BIDDING AND CONTRACT DOCUMENTS
ADDENDUM NUMBER ONE
STATE PROJECT NO. 19-045B-2

DATE: MAY 15, 2020

CAMDENTON MEMORIAL-LAKE REGIONAL AIRPORT

SUBJECT: ADDENDUM NUMBER ONE TO THE BIDDING DOCUMENTS FOR:
OVERLAY AND EXTEND RUNWAY 15-33

SUMMARY OF QUANTITIES

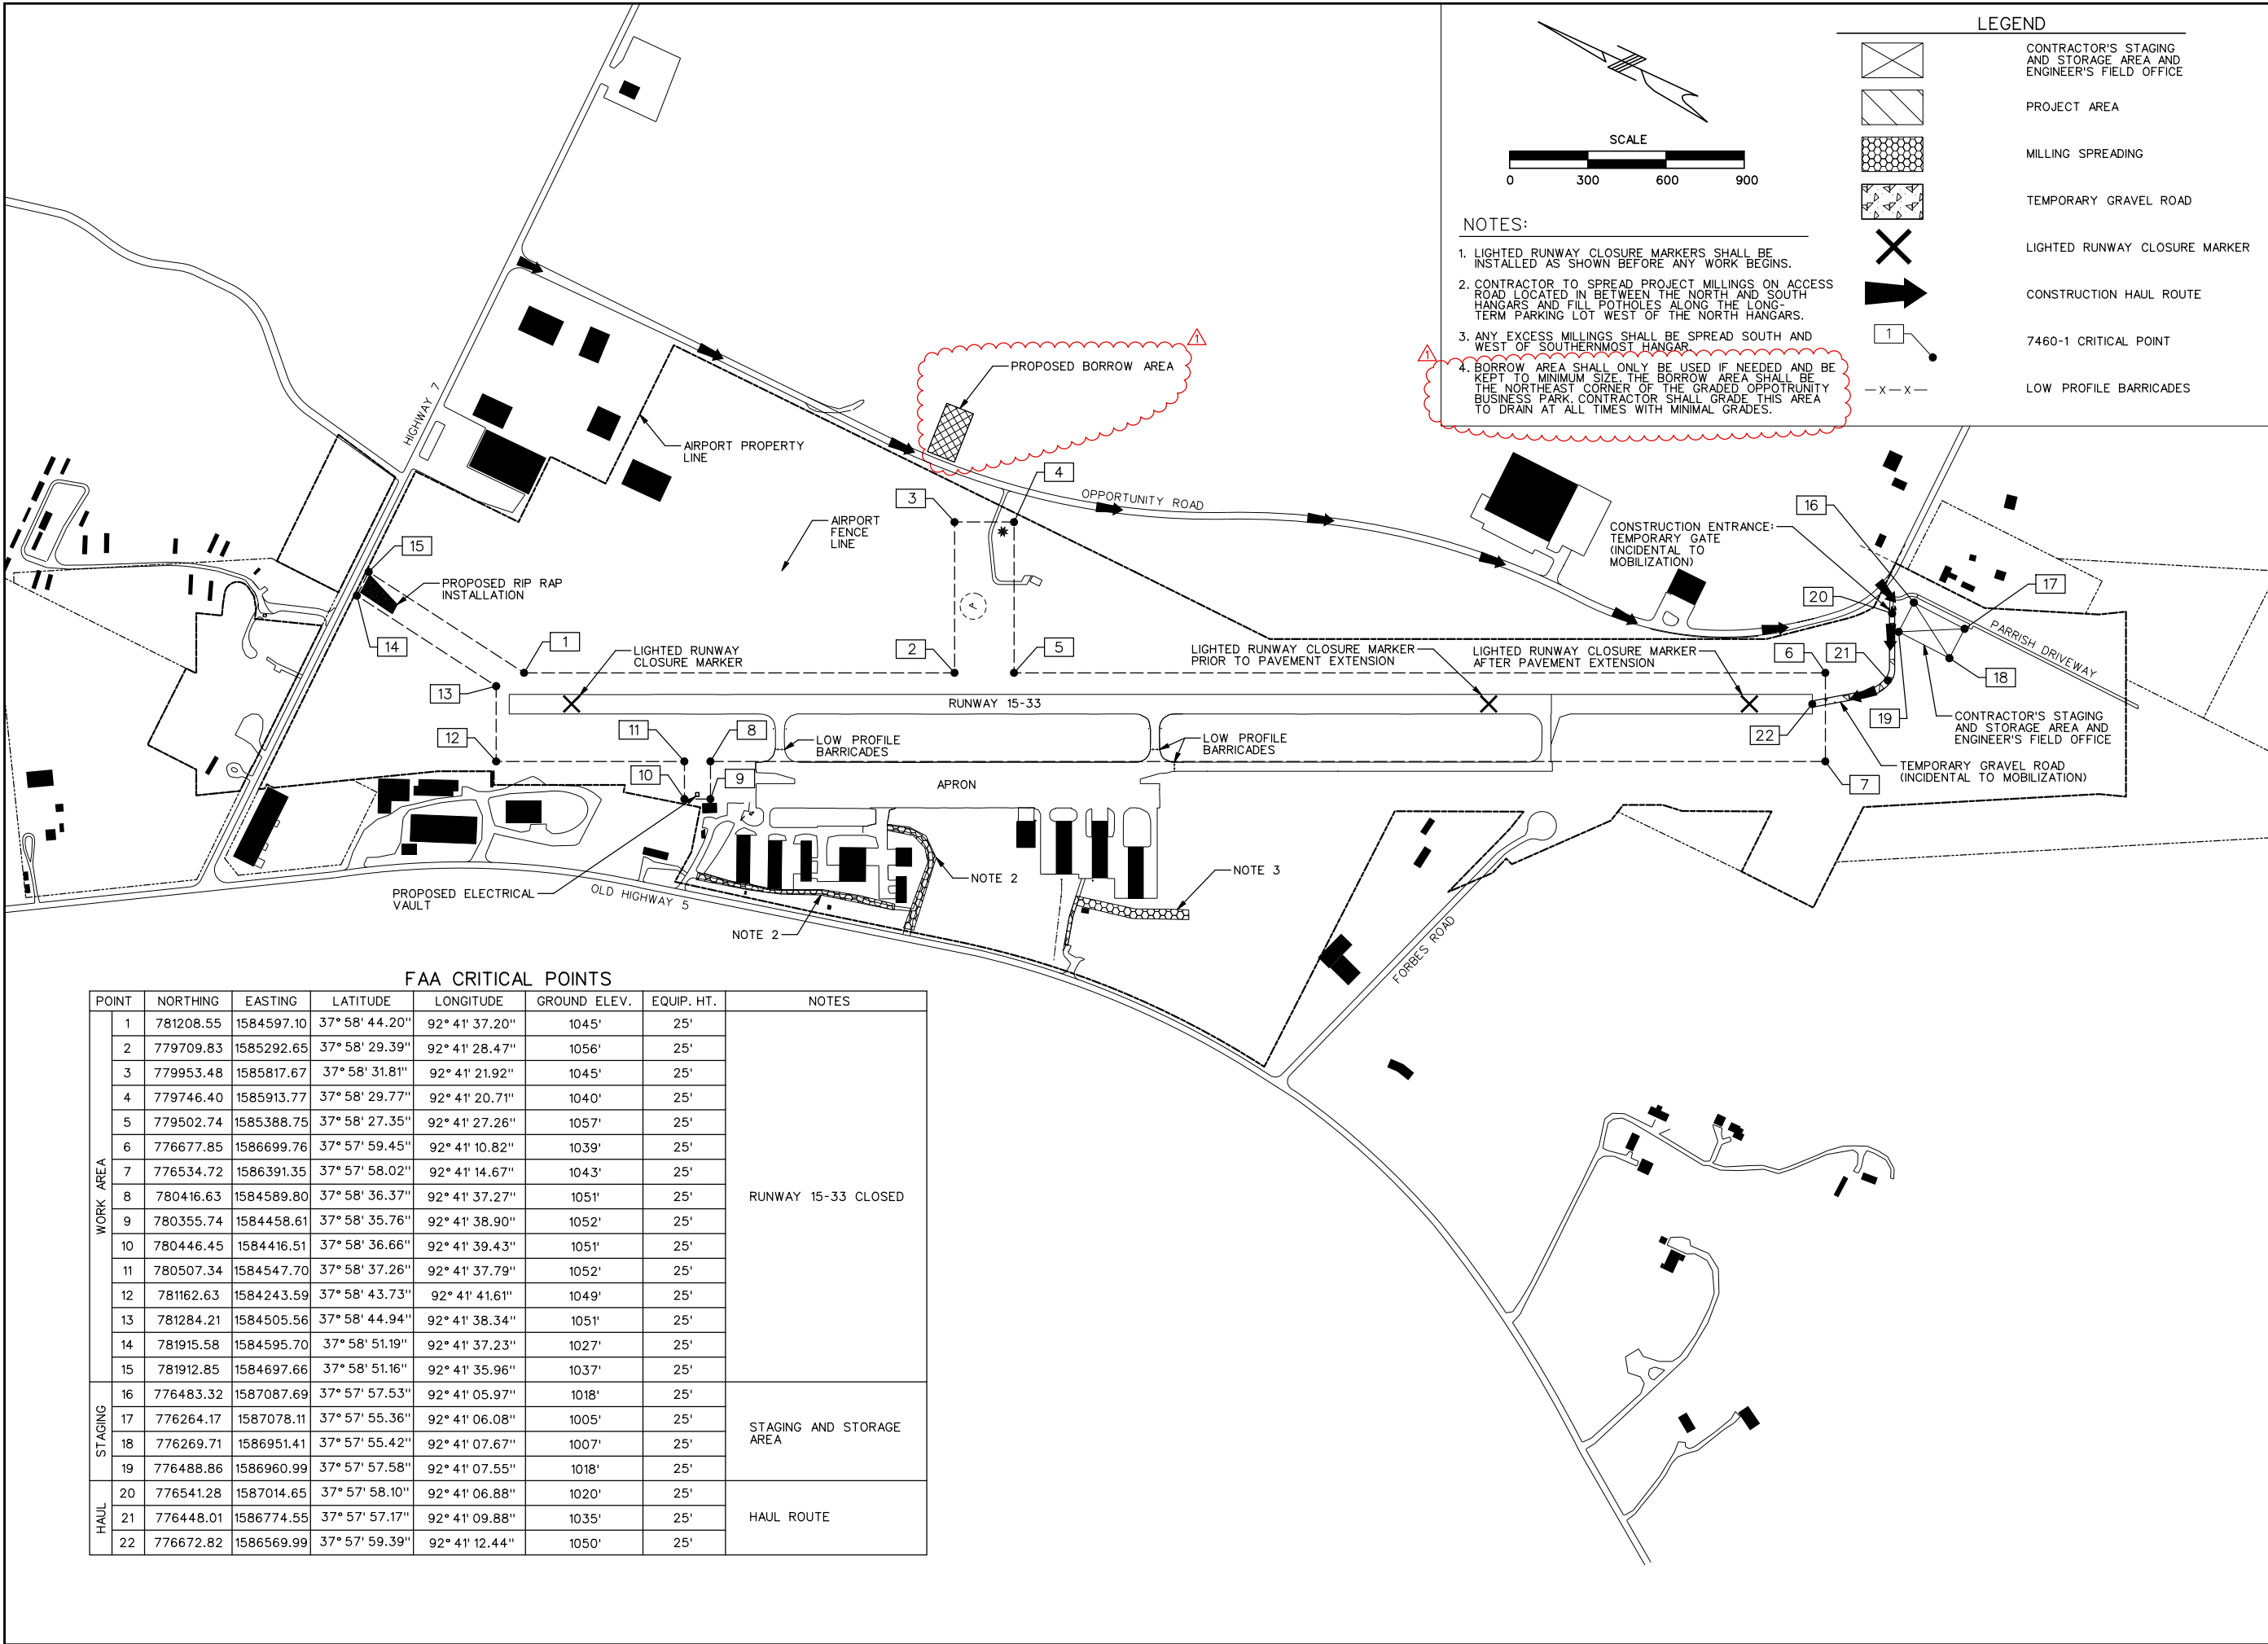
REPLACE Sheet 2 of 74 with REVISION 1.

Payment for excavation and embankment covered under Item P-152 is being switched from unclassified excavation to embankment in place. The quantity has been adjusted to reflect this.

SHEET 25 OF 74 SHEETS

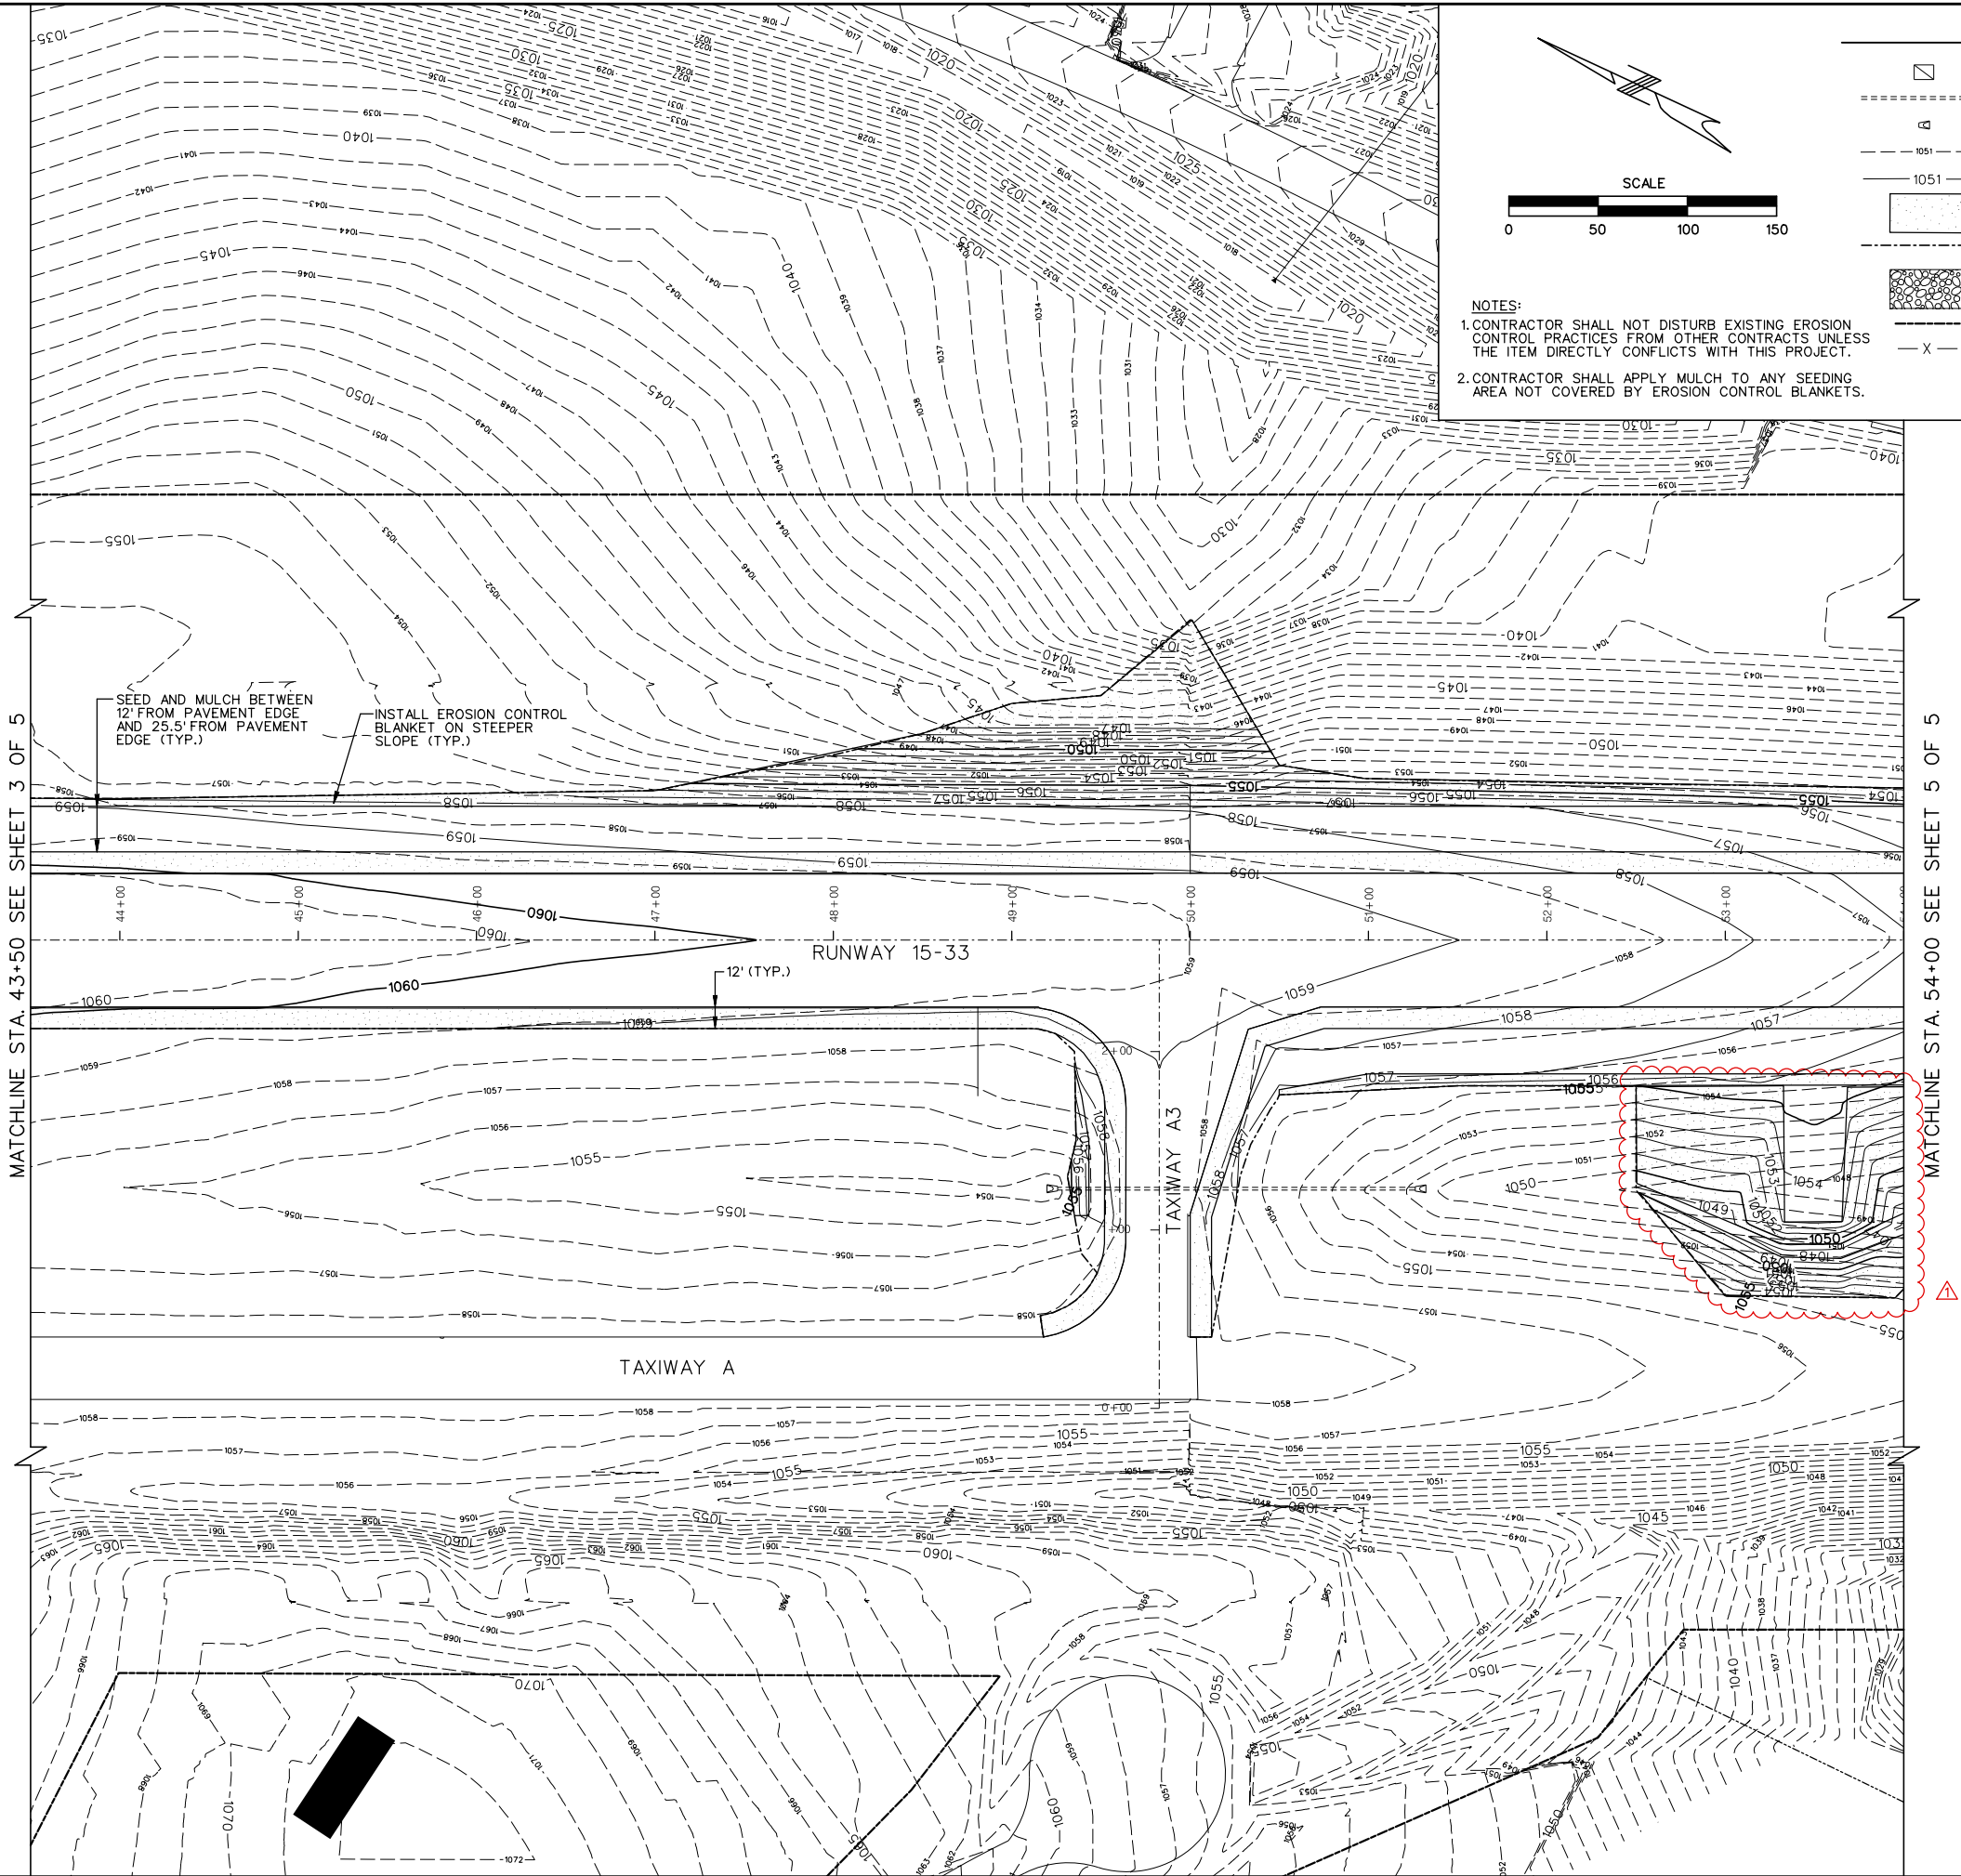
REPLACE Sheet 16 of 74 with REVISION 1.

The grading plan has been updated to allow for a graded pad to install the Runway 33 PAPI on.

SHEET 68 OF 74 SHEETS

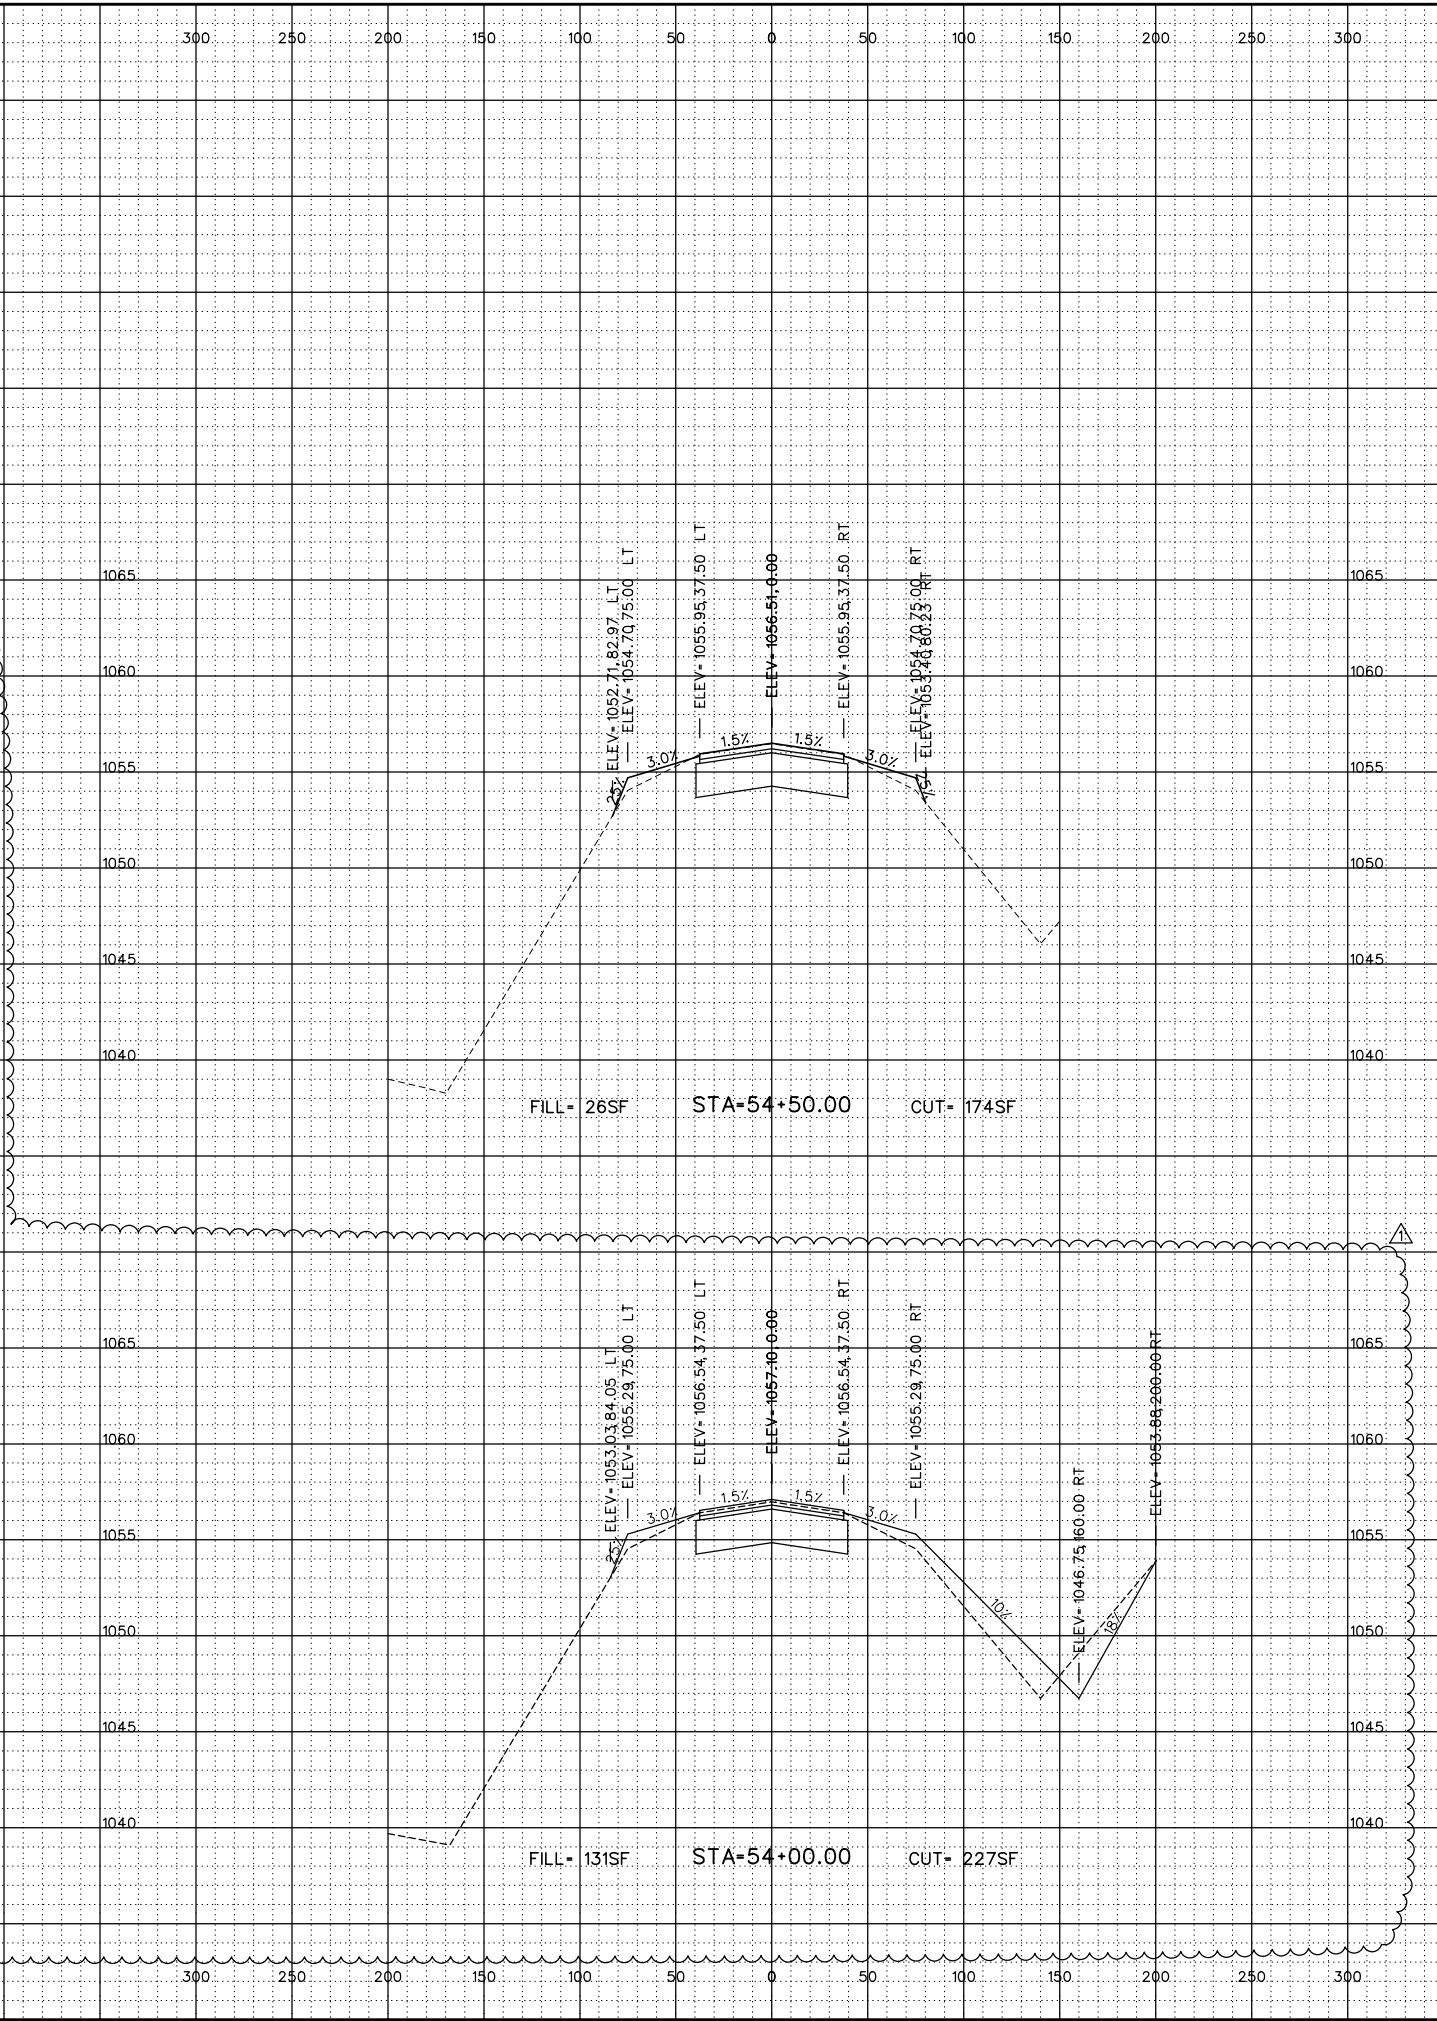
REPLACE Sheet 68 of 74 with REVISION 1.
